**RE - Carmacks–Stewart/Minto Spur Transmission Line Project Adequacy Review**

**YUKON ENERGY CORP.'S CARMACKS STEWART/  
MINTO SPUR TRANSMISSION LINE**

**ADEQUACY REVIEW REPORT**

**SUPPLEMENTARY INFORMATION**

Figure 1-8.1 –  
Tatchun caribou herd range

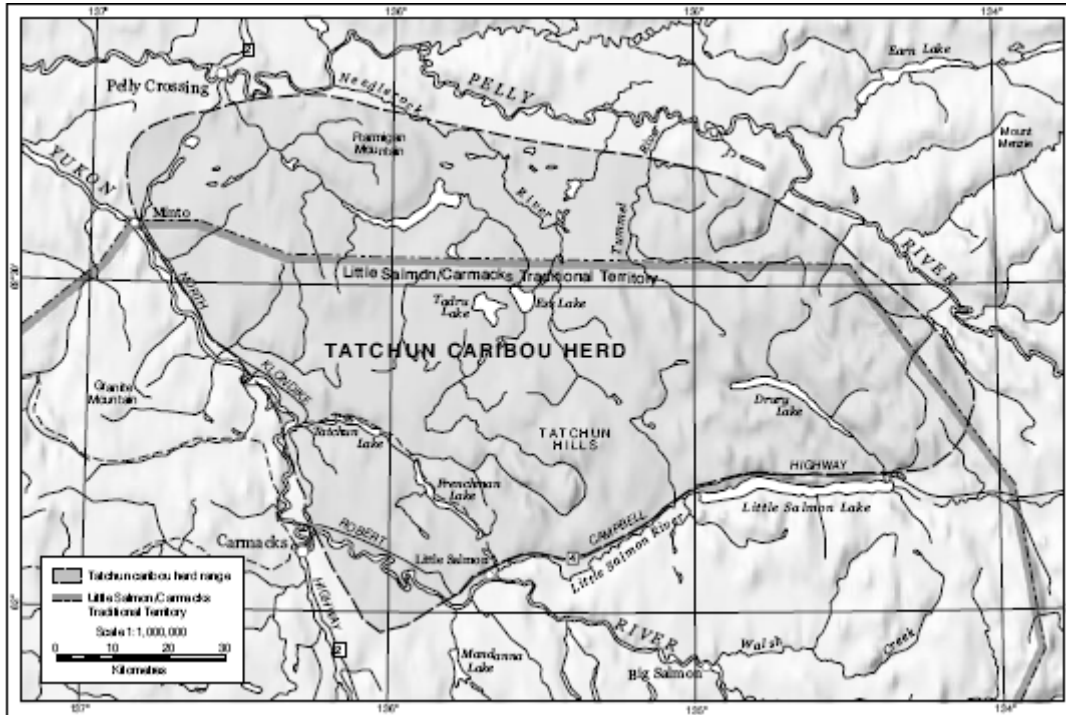
- 11       o Please provide information and maps (where relevant and appropriate) relating to the overlap  
12       between the proposed project and any specific wildlife habitats, ranges, movement corridors,  
13       etc.  
14       o Provide information regarding the Ethel Lake and Tatchun Caribou herds and bison, specifically  
15       spatial habitat use, in relation to the project.  
16       o Identify any implications concerning the distribution and abundance of habitat types that may  
17       influence the project.  
18       o In the course of proposal development we have been made aware that a YTG regional biologist  
19       noted locations of Sharp-tailed Grouse leks near the project (east of the Minto airstrip and  
20       Klondike Highway). Please identify these on an appropriate map and provide the GIS point  
21       files. Describe how the project considered this information.

17 The following diagram illustrates the Tatchun herd range, as per the Little Salmon Carmacks First Nation  
18 Community-based Fish and Wildlife Management Plan 2004-2009.

From May through to October caribou are generally found in alpine habitat for calving in the spring and rutting in the fall. In late October/early November they migrate to a large, forested winter range habitat until April. The Tatchun herd's winter range has been affected by wildfires that occurred in 1969, 1995 and 1998. According to the LSCFN Community-based management plan "the animals are still in good physical condition and show no signs of stress from the effect of fires on their range".

12  
 13 **Figure YESAB-YEC-2-1b**  
 14 **Revised Pelly Crossing Substation with Road Access**  
 15

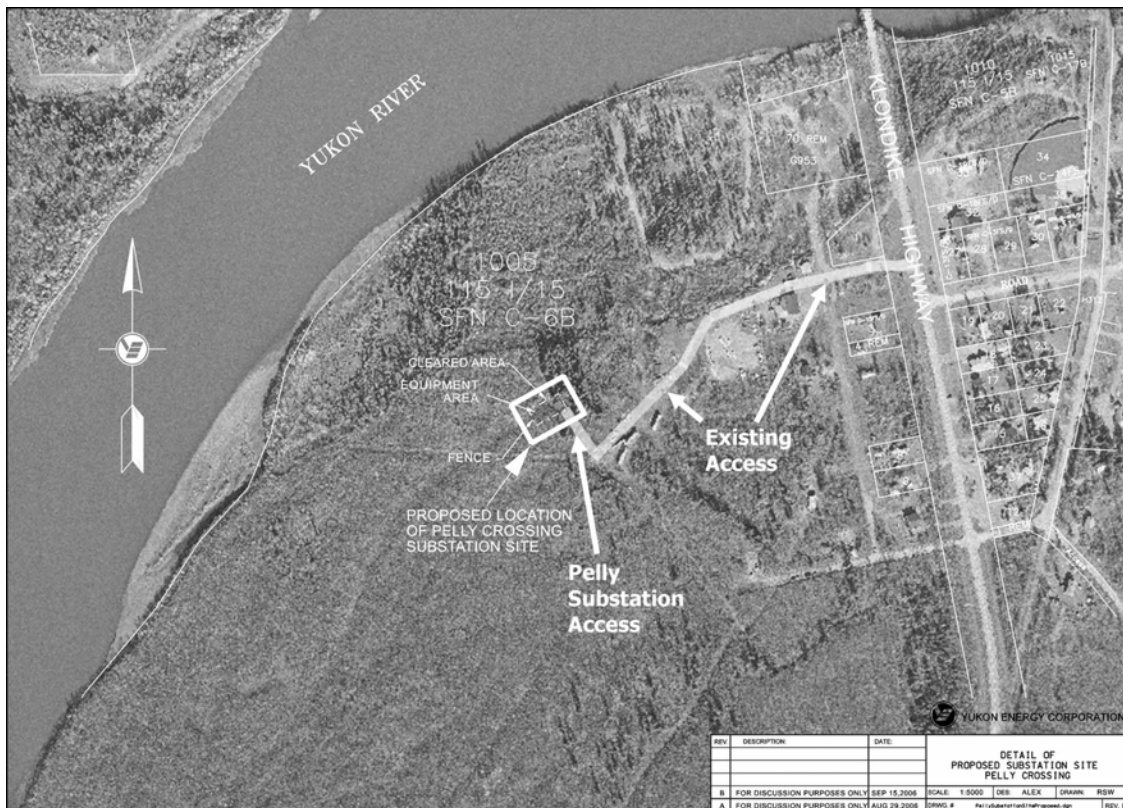
- 10 ○ Please provide a larger map containing the location of the Pelly Crossing substation in  
11 detail, and ensure a legend is included. This may be combined with the items in number 10  
12 (above).

16 **Pelly Crossing Substation (Figure 5.7-3):** The site is situated in the vicinity of other similar structures  
 17 (SFN Lands Equipment Yard) and is close to existing roads that are suitable for all-weather use. As stated  
 18 in YESAB-YEC-1-2 and 1-3, access will make use of the existing road in and around the SFN Lands  
 19 Department equipment yard, with the addition of a new single lane access road of approximately 30-40 m

1 in length to extend the road to the substation site. Figure YESAB-YEC-2-1b below shows the location of the  
 2 proposed all-weather road access corridor to the site from the Klondike Highway.  
 3  
 4 Terrain analysis of the site area (Appendix 6A-1, Map 6A-1-5) indicates that the proposed substation  
 5 location is north of an OW unit, or organic rich, poorly drained materials. The area is also known to have  
 6 fluvial silt and sand/gravel (Appendix 6A-2, Map 6A-2-2). Otherwise the area is generally stable and well-  
 7 drained, consisting of gravelly sand to gravelly loam. Vegetation cover is forested (Appendix 6C, Map 6C-5)  
 8 with low timber potential. The proposed site is located above the Pelly River flood plain. It is situated  
 9 adjacent to the proposed CS transmission line corridor, and its relative proximity to YECL's Pelly Crossing  
 10 distribution system (existing YECL diesel generation facility) minimizes the requirement for additional

16 Access road: approximately 30-40 m long  
 17 Substation cleared area: 50 m by 70 m; fenced area: 20 m by 40 m (See Section 5.7.2.2, pg. 5-23 of  
 18 Project Proposal Submission.
